## Recall Information Bulletin

**No:** C1007010 **Issued:** 10/16/2014

**Re:** ATF Oil Cooler Hose

Safety Recall C1007010 – ATF Oil Cooler Hose

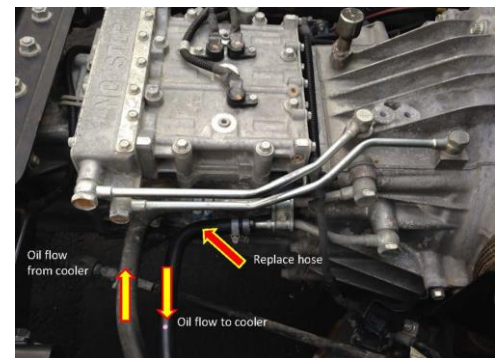
1. Check the lot number on the ATF oil cooler hose

As viewed from the underside of vehicle, looking upward.

(Example)  
Lot No.: OY01 and white lettering **Affected**

(Example)  
Lot No.: 4302 and yellow lettering **OK**

**LOT NUMBERS:**        **Affected – White lettering** with lot number **4301** or lower  
                                 **OK – Yellow lettering** with lot number **4302** or higher

## 2. Remove defective feed side ATF oil cooler hose

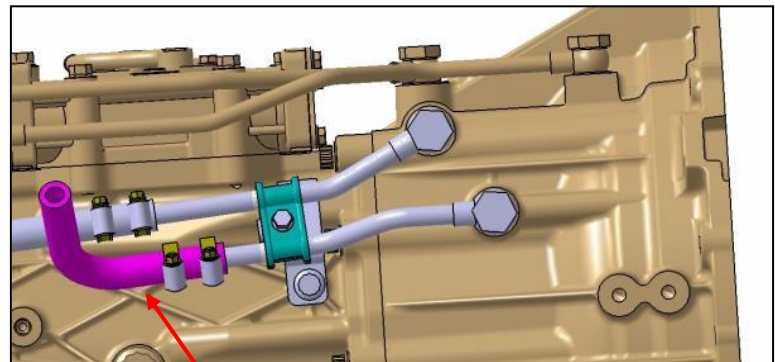
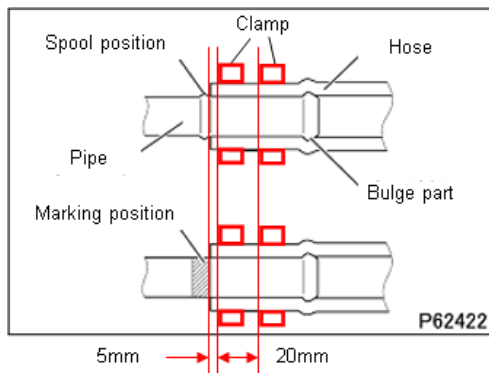
Remove the oil cooler hose from the transmission side first. Raise the hose to drain fluid into the cooler line. This will reduce the volume of fluid lost. Remove the hose from the cooler line.

Install the replacement hose. Tighten the clamps as shown below to a tightening torque of 2 ft.lbs. (3.0 Nm).
